## Report to the Sydney Eastern City Planning Panel

### COUNCIL ASSESSMENT REPORT

| <b>DA Number</b>  | DA-125/2012/C  |
| <b>Proposed Development</b>   | Section 4.55(2) modification to roof design, ground floor entry, façade stairwell, and increase in height, extension of basement parking and penthouse reconfiguration.  |

**Figure 4: Level 8 (Penthouse level floor plan) as approved in DA-125/2012/A**

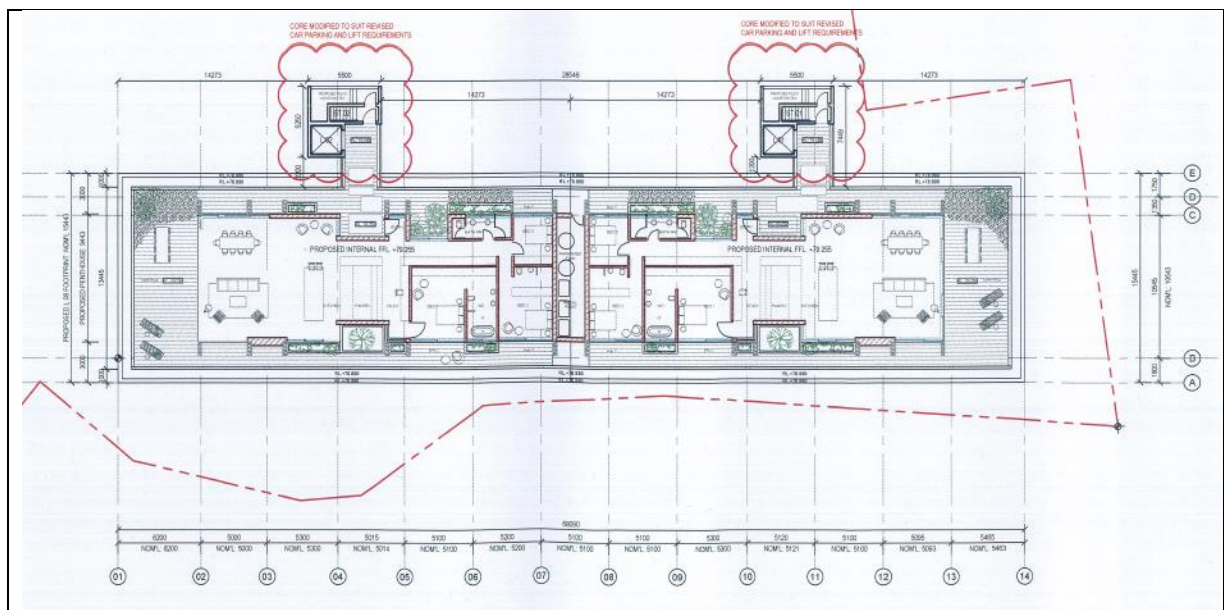
The penthouse apartments are already excessively large with more than double the required floor space and provide sufficient height to satisfy the Apartment Design Guide of SEPP 65. It is not necessary to further increase this level and unreasonable to impose further impacts upon the surrounding locality.

The additional floor space contained at the penthouse level involves infilling recessed areas of the floor plate to provide a consistent alignment along the eastern and western elevations. Although the penthouse level is set back from the level below on all sides, the previously approved design with recessed areas and varied setbacks along these prominent facades provides articulation to the built form of the additional level. The reduction in the variation to the setbacks increases the bulk and scale of this level when viewed from surrounding properties and the public domain. The existing building itself already grossly exceeds the bulk and scale of surrounding properties. Incrementally increasing the floor space is considered to further exacerbate amenity impacts upon neighbouring properties, and the incompatibility of the building with the surrounding area and the desired future character. Whilst the applicant has described the additional overshadowing as minor having negligible impact, any additional over shadowing is considered unacceptable given that the building is already well over the maximum building height and density controls. However minor the additional overshadowing is argued to be, the additional impact exists and does not preserve the amenity of the locality. The proposal is therefore inconsistent with objectives (b), (c) and (d).

**Figure 5: East elevation as approved in DA-125/2012/A**

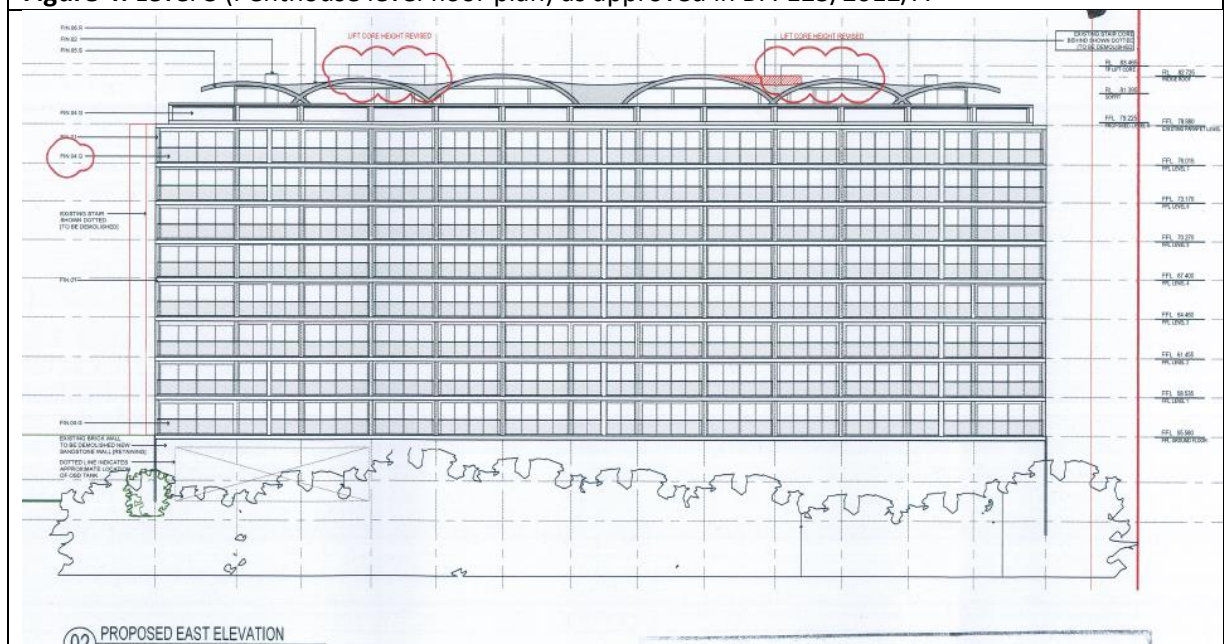
The current modification application seeks to again increase the height of the main building, by a further 695mm to RL 83.42 and increase the height of the lift core by a further 615mm to RL 84.08. Overall the existing building will be increased in height by 4.1m (to lift core) from the existing building on the site to a maximum of 28.65m. That part of the building containing the additional storey is 3.44m above the height of the existing building.

The additional height to both the main penthouse roof and the lift core will result in additional overshadowing of the public domain, and neighbouring properties. Although only anticipated to be minor due to the proposed modification, the cumulative effect from the upper floor addition and the incremental height increases, exacerbates this existing impact and does not 'preserve' the environmental amenity of neighbouring properties and public spaces. The proposed modification is not consistent with objective (a).
